Process Sheet

Customer :	CU-DAR001 Dart Helicopters Services	Drawing Name :	350 SKIDTUBE ASSEMBLY RH
Job Number :	41061		
Estimate Number :	10265		
P.O. Number :		Part Number :	D350636012
This Issue :	07/08/2008	S.O. No. :	
Prsht Rev. :	NC	Drawing Number :	D2750 UNDER REVIEW <i>PH 03.08.12 UPDATE PER PSI 9413</i>
First Issue :	//	Project Number :	N/A
Previous Run :	41037	Drawing Revision :	
Written By :		Material :	
Checked & Approved By :	<i>JLD 08.8.08</i>	Due Date :	30/08/2008
Comment :	Est Rev:I 02.09.25 Rearranged procedure steps KJ Est Rev:J 06-03-29 As per Rev D EC Est Rev:K 06-07.13 As per dsi9343 EC Est Rev:L 07-07-28 Added SS Wearplates(Rev E) JLM Verified By:EC Est Rev:M 08-04-22 update steps 4,13 DD verified by:EC		
Qty:	1	Um:	Each

DART SERVICE INSTRUCTION

A	NEW ISSUE	PH	08.05.14
REV.	DESCRIPTION	BY	DATE
DESIGN	PH	DART AEROSPACE USA, INC PORT HADLOCK, WA	
DRAWN	PH		
CHECKED		DRAWING NO.	REV. A
MFG. APPR.	N/A	DSI 9413	SHEET 1 OF 3
APPROVED		TITLE	SCALE
DE APPR.		WEARSHOE MODIFICATION	NTS
DATE	08.05.14	COPYRIGHT © 2008 BY DART AEROSPACE USA, INC THIS DOCUMENT IS PRIVATE AND CONFIDENTIAL AND IS SUPPLIED ON THE EXPRESS CONDITION THAT IT IS NOT TO BE USED FOR ANY PURPOSE

FIGURE 1 - WEARPLATE MODIFICATION

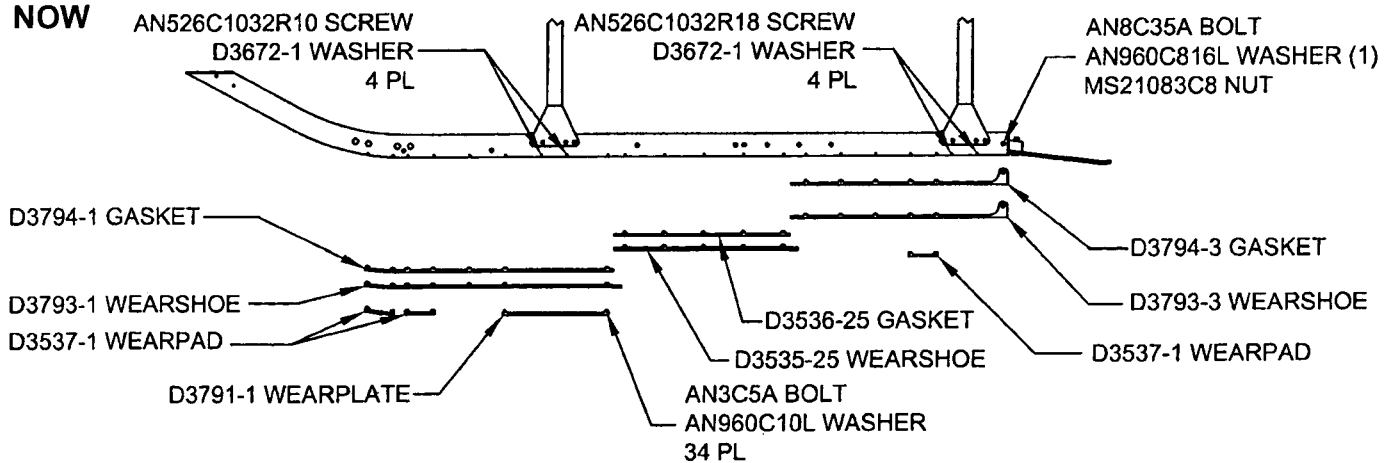
THE WEARPLATES ON D350-636-011/-012/-013/-014 SKIDTUBES AT CHG 004 (AND LATER) HAVE BEEN MODIFIED AS SHOWN IN FIGURE 1 BELOW TO ELIMINATE THE POSSIBILITY OF INTERFERENCE BETWEEN THE WEARPLATES AND CROSSTUBE SADDLES AT INSTALLATION. THERE IS NEGLIGIBLE WEIGHT CHANGE ASSOCIATED WITH THIS MODIFICATION.

(AN526C1032RXX SCREW LOCATIONS NO LONGER USED TO MOUNT WEARSHOES)

TO INSTALL THE DSI 9413-011 KIT, REMOVE THE EXISTING WEARSHOES/GASKETS UNDER THE FWD/AFT SADDLES AND INSTALL NEW WEARSHOES/GASKETS AS SHOWN IN FIGURE 1. PLUG UNUSED HOLES WITH AN526C1032RXX SCREWS AND D3672-1 WASHERS. INSTALL SCREWS WITH SIKAFLEX -241/-291 OR PROSEAL 890 OR MIL-S-8802 CLASS 'B2' SEALANT AS SHOWN IN FIGURE 1. NOTE: SOME OF THE PREVIOUSLY INSTALLED HARDWARE IS NO LONGER REQUIRED.
